APPLICATION NO.	FILING DATE	FIRST NAMED INVENTOR	ATTORNEY DOCKET NO.	CONFIRMATION NO.
10/594,554	09/27/2006	Helmut Figgenger	677/45189	3544
23643 7590 09/22/2008 BARNES & THORNBURG LLP 11 SOUTH MERIDIAN INDIANAPOLIS, IN 46204			EXAMINER COOLEY, CHARLES E	
			ART UNIT 1797	PAPER NUMBER
			MAIL DATE 09/22/2008	DELIVERY MODE PAPER

Office Action Summary	Application No. 10/594,554	Applicant(s) FIGGENER ET AL.	
	Examiner Charles E. Cooley	Art Unit 1797

NON-FINAL OFFICE ACTION

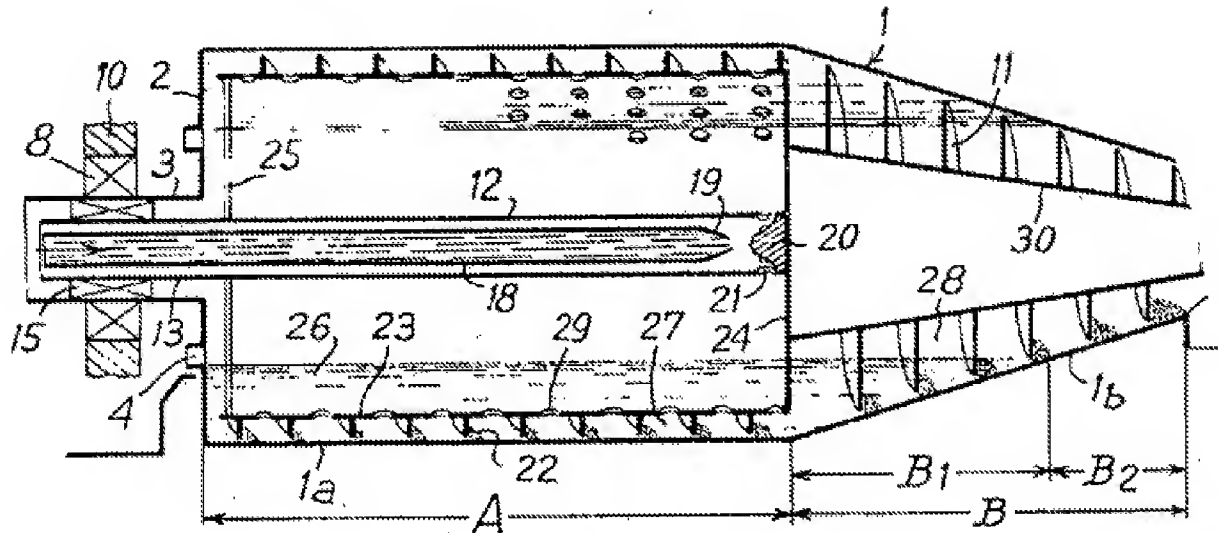
9. **Claims 1, 3, 4, 6, 7, 8, 9, 10, 11, 12, 13, 14, 15, and 17 are rejected under 35 U.S.C. 102(b) as being anticipated by FR 2057600.**

FR 2057600 discloses a screw type drum centrifuge as seen below with the recited angled/widening deflector plate (proximate 4 in Fig. 3); axially protruding projection 4; the plate having multiple parts with various angles/bends; and a screw 11 in the drum 1.

FIG. 1

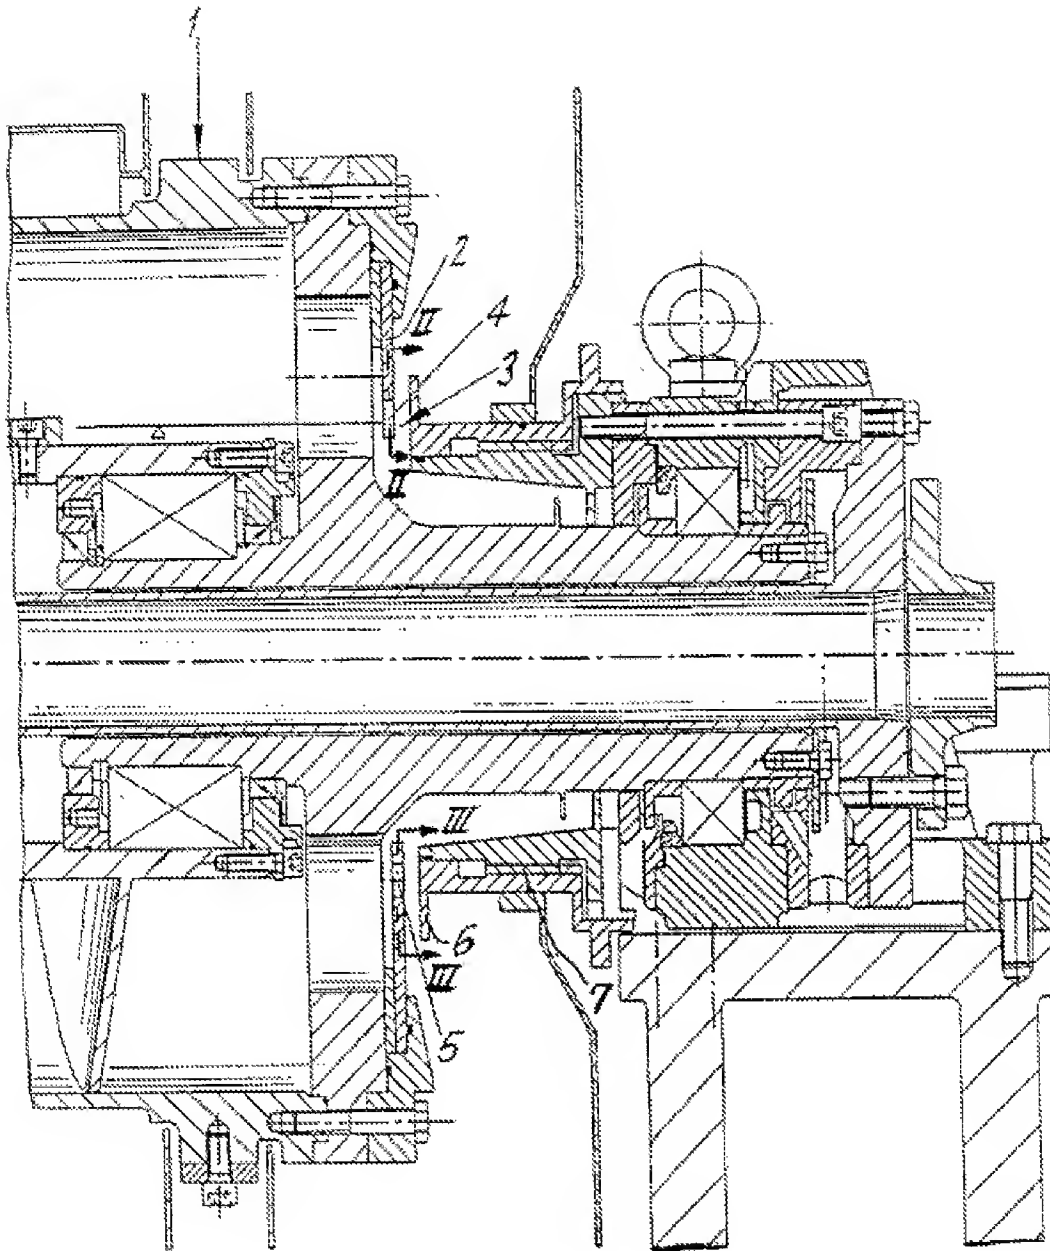
10. Claims 1, 2, 3, 4, 6, 7, 8, 10, 11, 12, 13, 14, 15, 16, and 17 are rejected under 35 U.S.C. 102(b) as being anticipated by Figgner et al. (US 5,593,377).

Figgner '377 discloses a screw type drum centrifuge as seen below with the recited angled/widening deflector plate (to the right of 3, 4 in Fig. 1); the plate having multiple parts with various angles/bends; and a screw in the drum 1; and an orifice plate 6 whereby a distance between passage 3 or 4 and the orifice plate is adjustable via sleeve 7.

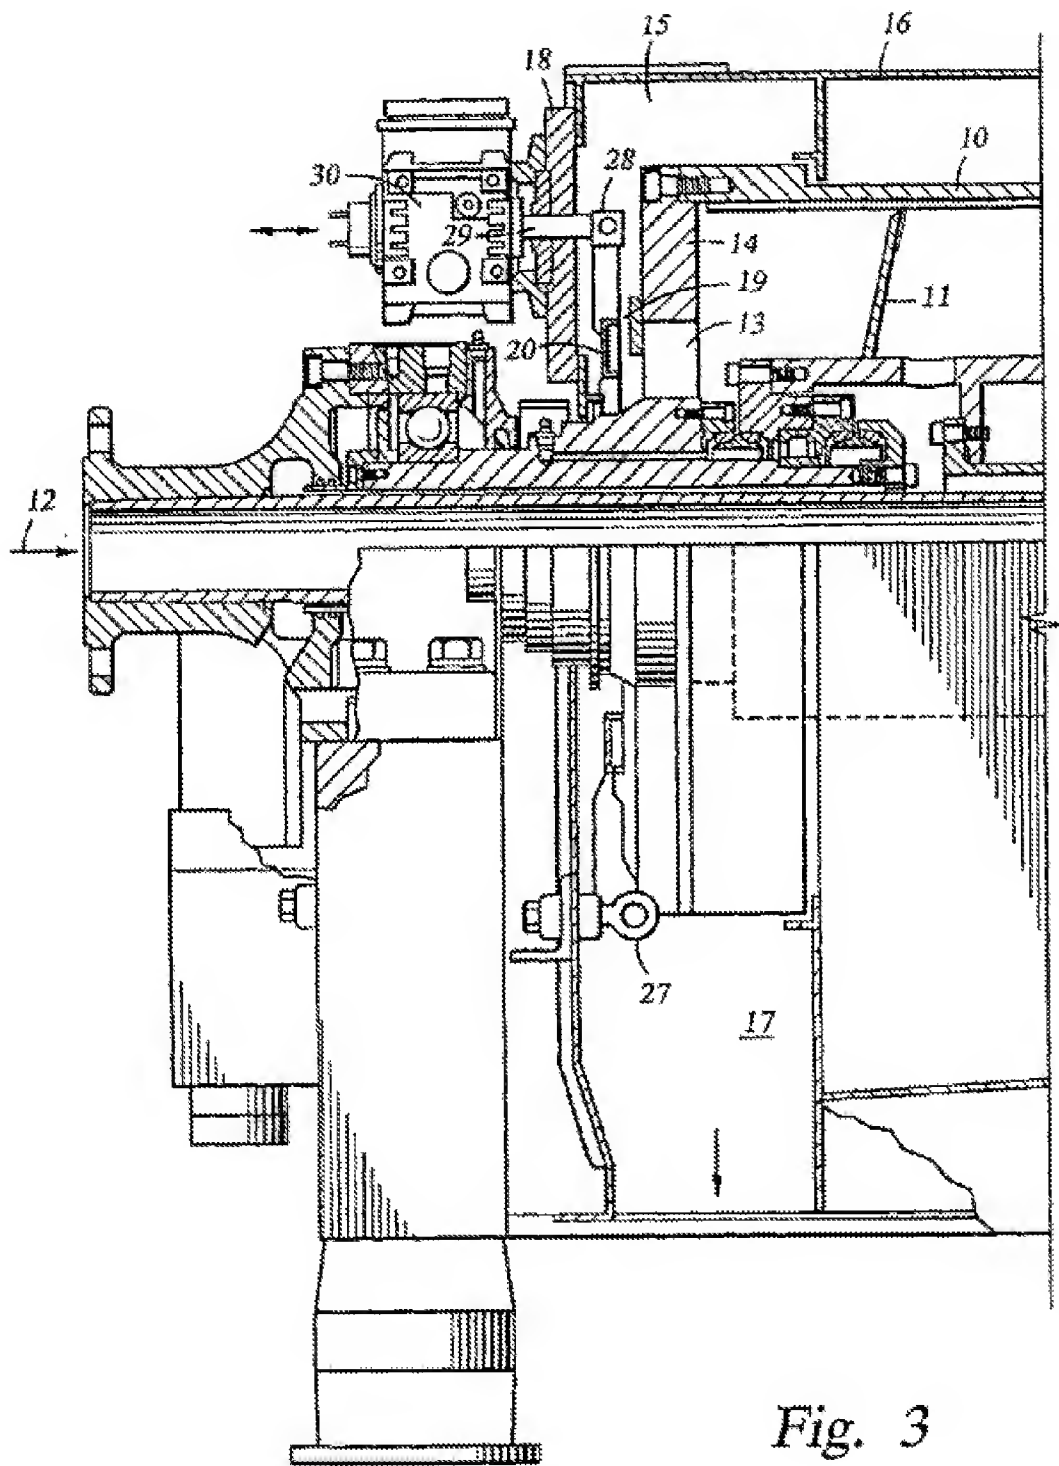
11. Claims 1, 3, 4, 5, 6, 7, 8, 10, 11, 12, 13, 14, 15, 17, 18, 19, 20, and 21 are rejected under 35 U.S.C. 102(b) as being anticipated by Feldkamp et al. (US 2004/0058796 A1).

Feldkamp '796 discloses a screw type drum centrifuge as seen below with the recited angled/widening deflector plate 20 which degree of inclination is adjustable via adjusting device 30; the plate having multiple parts with various angles/bends; a screw 11 in the drum 10; a collecting chamber 15; the deflector plate 20 having axial bolts (the bolt proximate 27 and the bolt 29), having radial bolts (the bolt below 28 and above 27), and having a ring 27; and wherein an annular gap is formed between the weir 13 and a ring plate (to the left of 20 in fig. 3) outside the centrifugal drum, which annular gap is one of completely and partially surrounded over its axial dimension by the widening deflector plate 20. See particularly ¶ [0012] – [0018].
